Technical Service Bulletin

MODEL(S) AFFECTED: i-mop XL PLUS model part number 1251236 (manufactured before s/n 331538 or P300964)
i-mop XXL PLUS model part number 1251235 (manufactured before s/n 630163 or P600163)

SUBJECT: The machine is designed with a park position shut-off switch to prevent battery discharge when not in use. There's been a couple reports that when the machine is in the park position, the control panel begins to beep and light up intermittently. The reason, we've discovered that some PCB boards (1:60) may be affected by a magnetic disturbance causing the metal ball within the tilt switch to not function properly.

PCB Board
Part No.
1251756

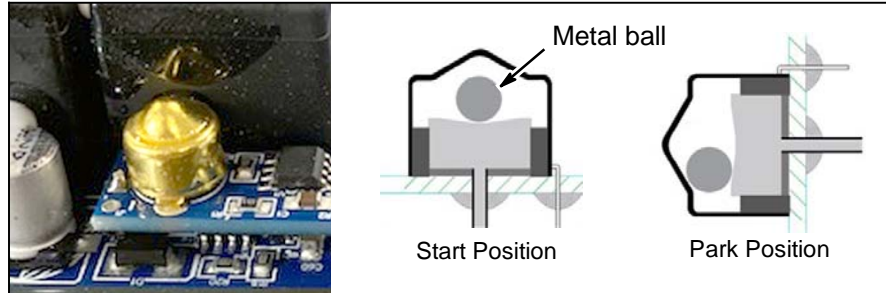
Park Position Shut-off Switch (i.e. Tilt Switch)

PURPOSE: To repair the above issue, order replacement PCB board p/n 1251756. In the meantime, it's recommended to remove batteries during machine storage.

NOTES: **Warranty Information:** Standard warranty terms apply.
Machine production recently implemented an upgraded PCB board with an electro-plated non-metal tilt switch ball to eliminate issue. A new PCB board service kit is currently under development.
